Independent Review to assess whether there are Economic Partial Solutions to Problems caused by Intermittent Storm Discharges to the Thames Tideway – Phase1

Final Report [incorporating TTSS November 2005 Supplementary Report update]

Ofwat Ref: PROC/01/0021

February 2006

Fig 6.1 Showing outline of Solution X

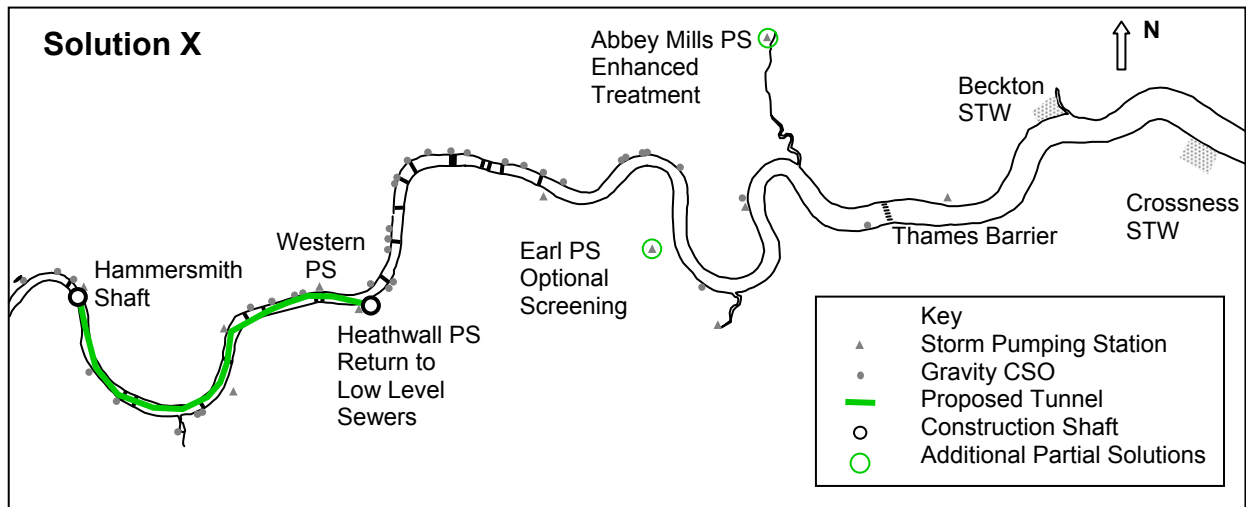
Aesthetic Improvements -This element also targets all the aesthetic pollution discharged directly into the upper reaches. Excess flows from larger storms will be pumped to the screening plant at Heathwall rather than returned to the sewer. Whilst proportionally, this represents only 23% of the sewage-derived solids entering the Tideway, without this intervention, much of these solids would have migrated to the middle reaches of the Tideway. When combined with the Abbey Mills treatment plant this element enable some 75% of the total sewage-derived solids by volume to be targeted at just over 50% of the cost of Option A (Ref.).

In the longer term, nothing in Solution X precludes the installation, at a later date, of measures to deal with some of the larger overflows in the lower middle reaches such as Earl, Deptford and Charlton. In fact, a discrete screening plant at Earl could be added whilst maintaining a favourable comparison with Option A (Ref.). This has also been included in our Table 6.3 worst case scenario for Solution X+. It illustrates that the capital cost and cost per percentage of objective achieved still remain better than Option A (Ref.), except for DO as discussed previously. We do not believe that Solution X+ offers any appreciable benefit over Solution X and therefore our recommendation is that only Solution X is considered further.
